Agenda
Village of Arlington Heights
Design Commission
Community Room, 3rd floor

Arlington Heights Village Hall
33 S. Arlington Heights Road
Arlington Heights, IL 60005
July 9, 2019
6:30 PM

STAFF DESIGN COMMISSION REPORT

Project Name: 836 N. Dunton Ave.
Project Address: 836 N. Dunton Ave.
Prepared By: Steve Hautzinger

EXISTING
ELEVATION STUDY
SCALE: 1/8" = 1'-0"

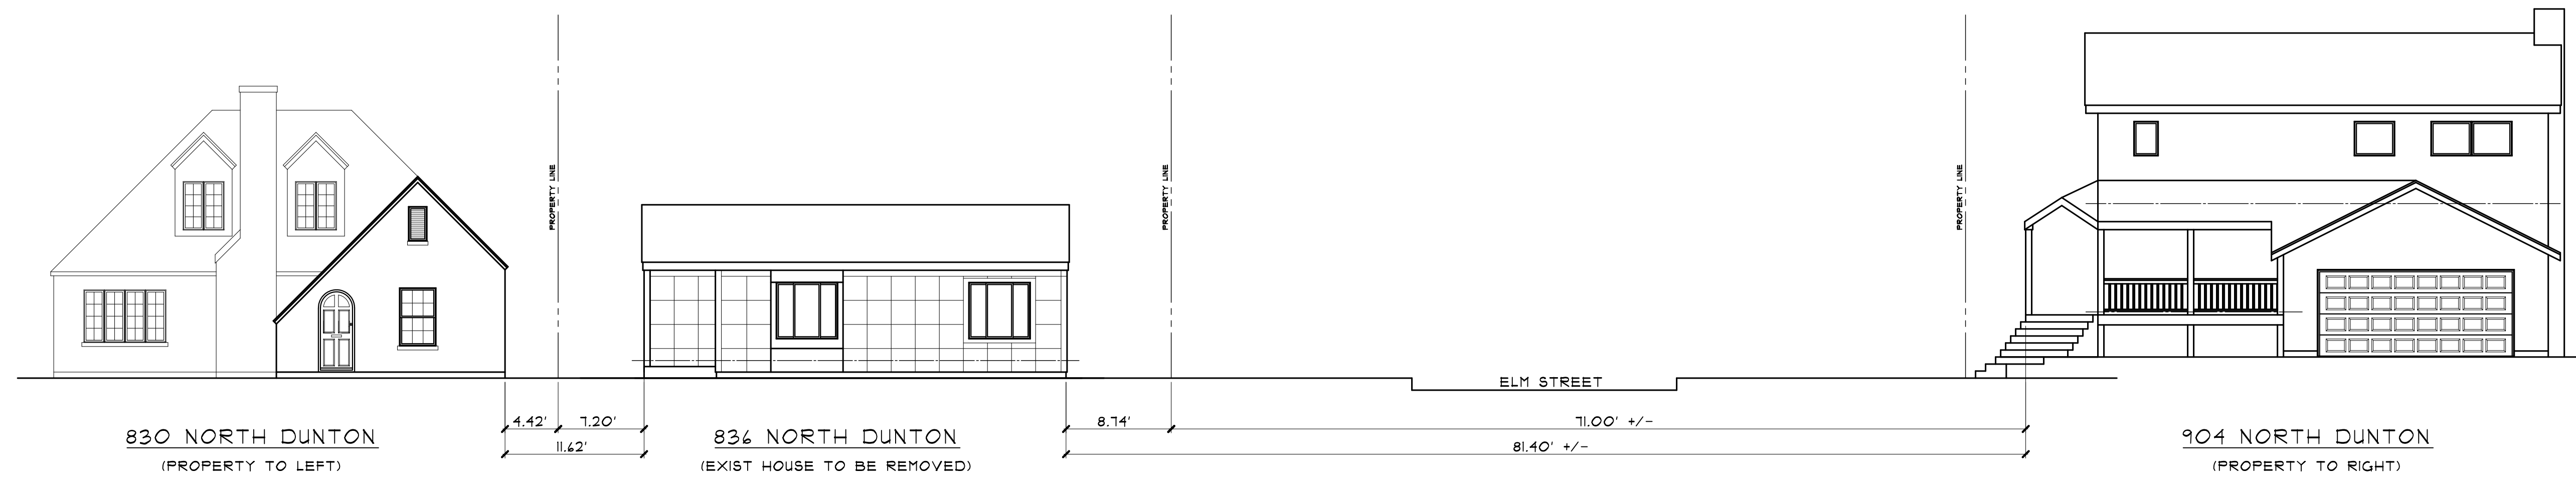
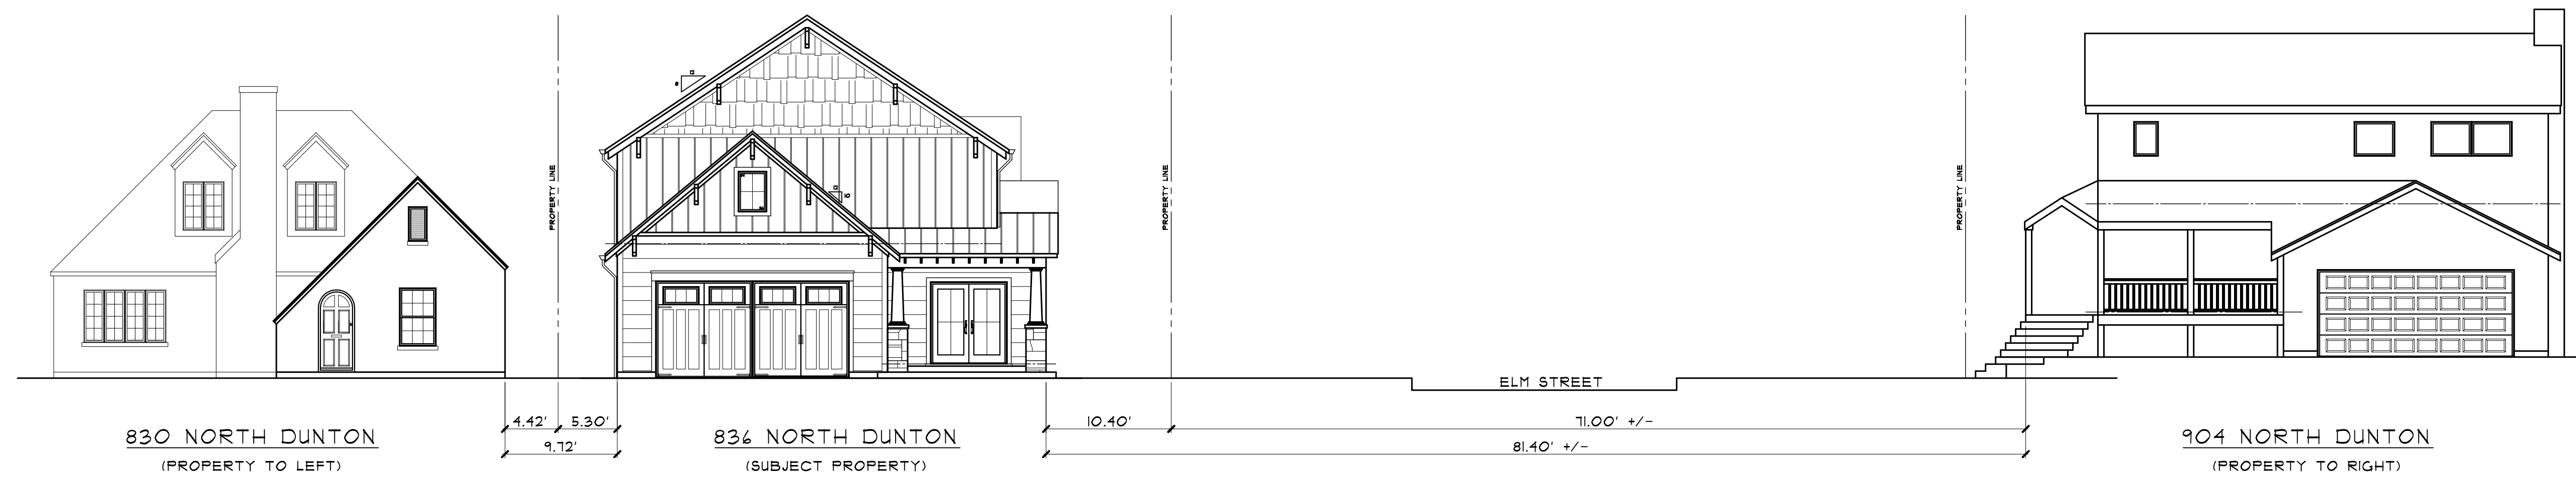
Overall, the proposed new house has a traditional style and detailing that fits well with the character of the neighborhood. However, the front of the house is oriented north, and the attached garage is oriented towards the street frontage on Dunton Avenue. While there are some front facing garages on the street, the majority of the houses have garages setback or detached in the rear yard. As proposed, the garage dominates the east elevation, and it does not work well with the context of the neighborhood. It is recommended that the garage be relocated to the rear yard, either attached or detached.

EAST ELEVATION

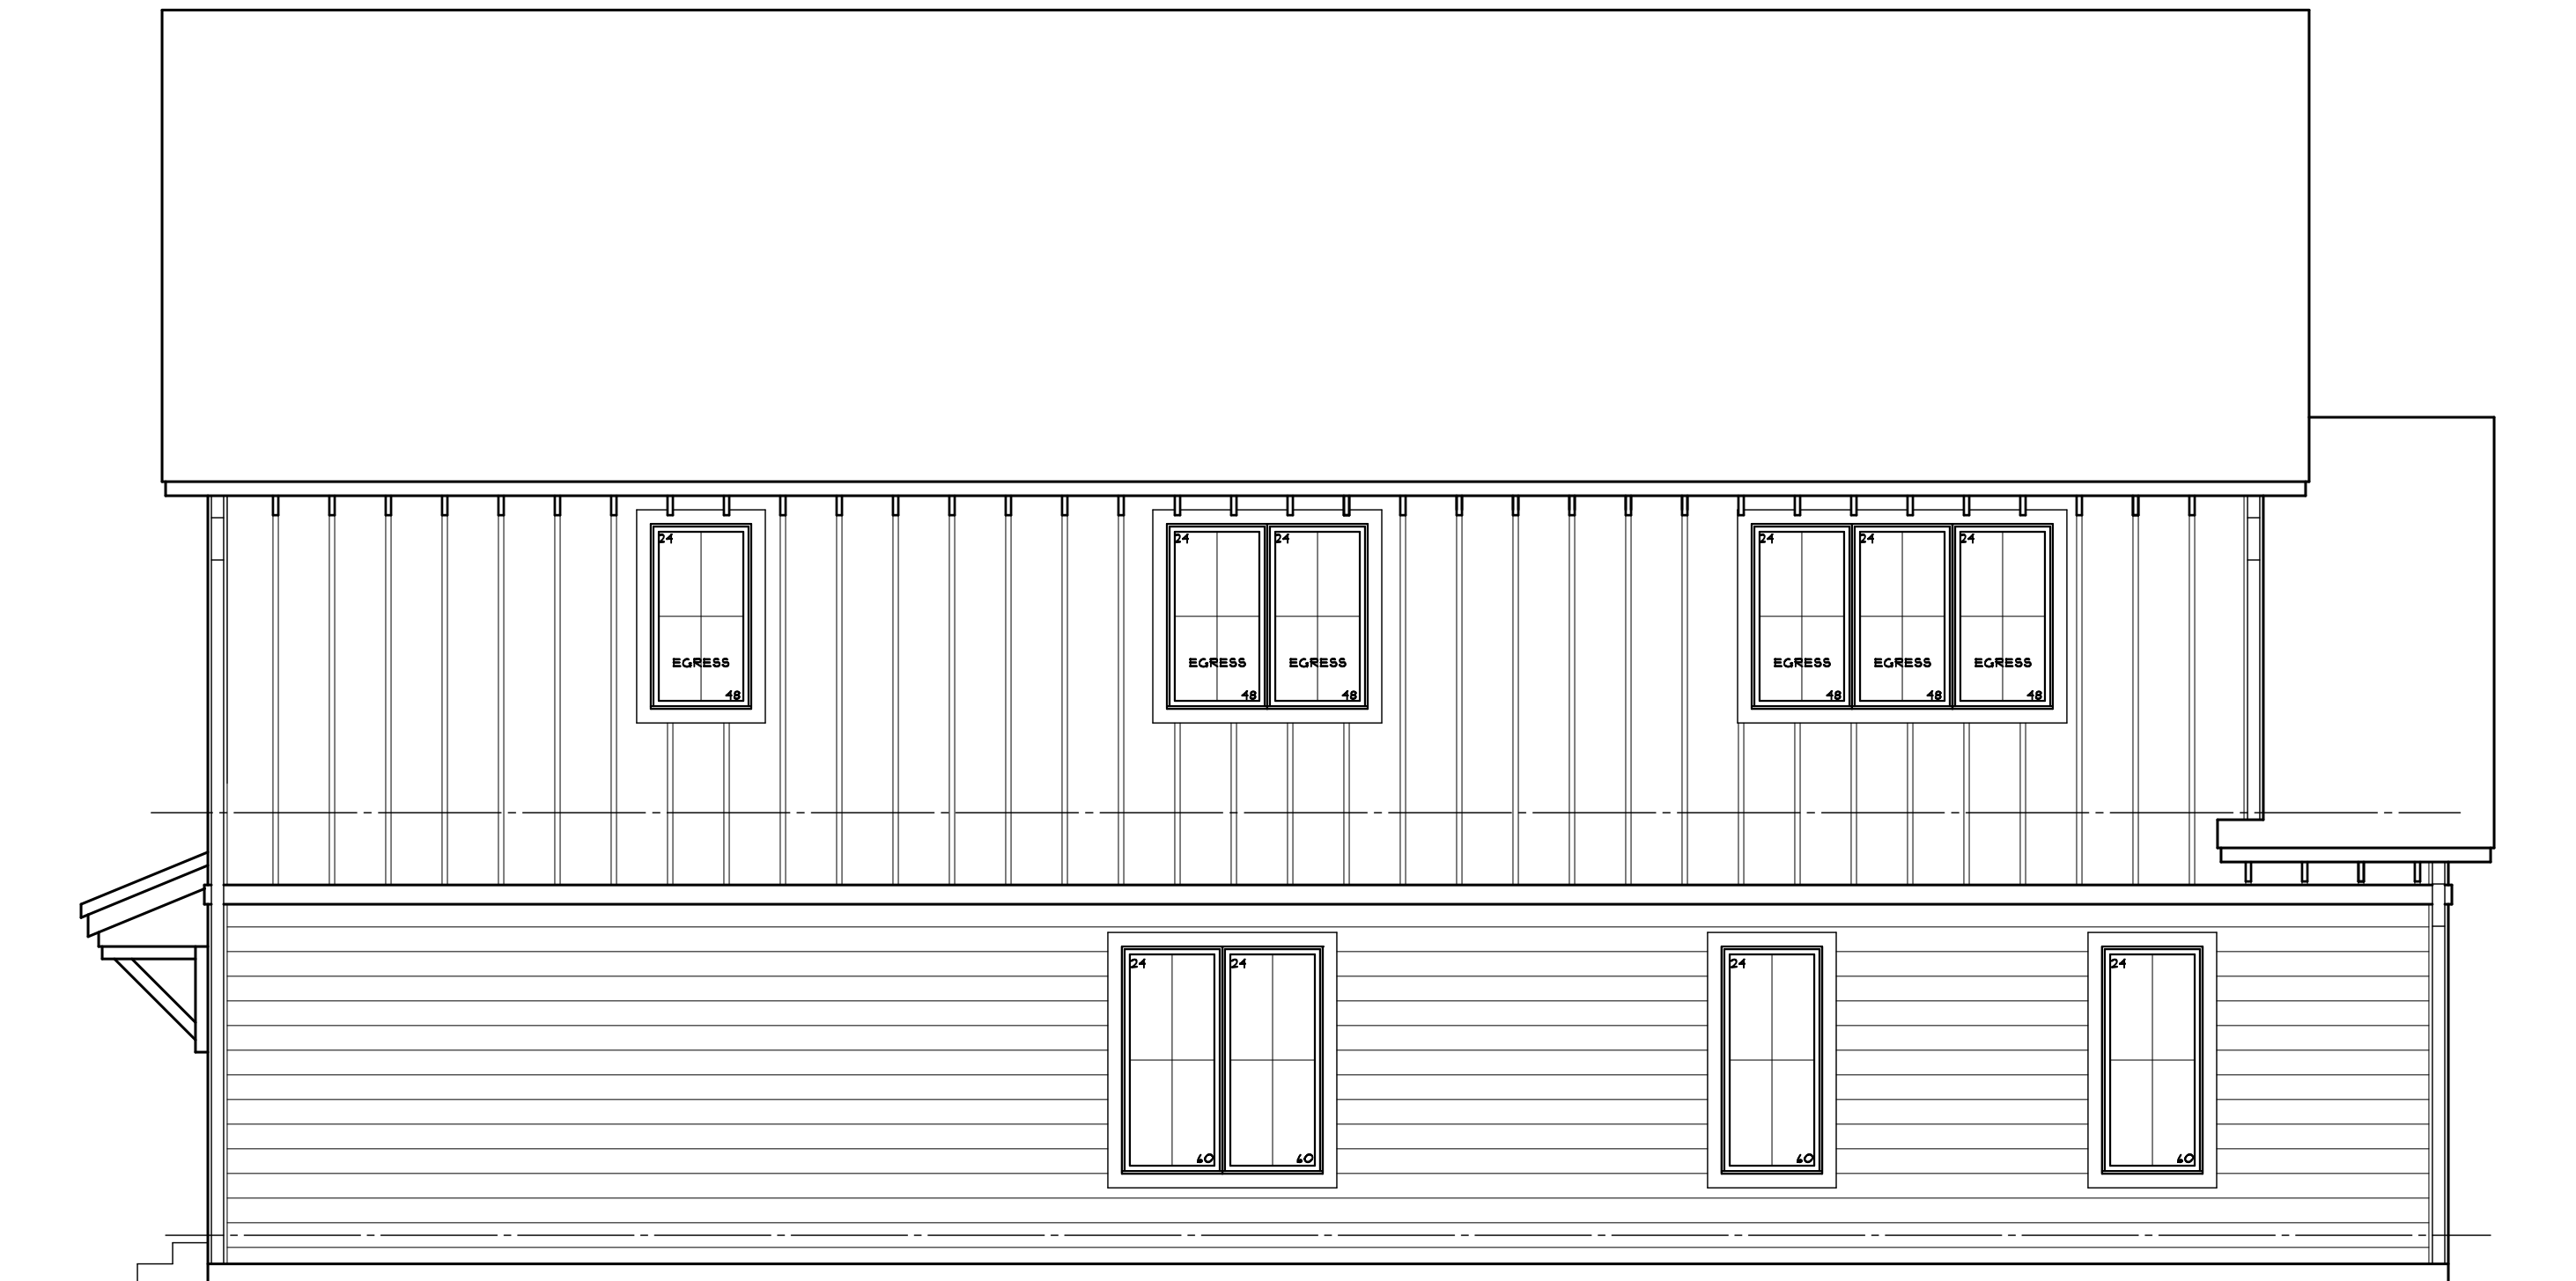
3. If the Design Commission finds the proposed garage configuration acceptable, then it is recommended that a window be added to the second floor of the east elevation to fill the blank wall space.

If the Design Commission finds the proposed garage configuration acceptable, then it is recommended that a window be added to the

second floor of the east elevation to fill the blank wall space. Also, the garage door is proposed to be black which will have a bold appearance against the white siding. It is recommended that the garage door color be changed to white to downplay the appearance of the garage.
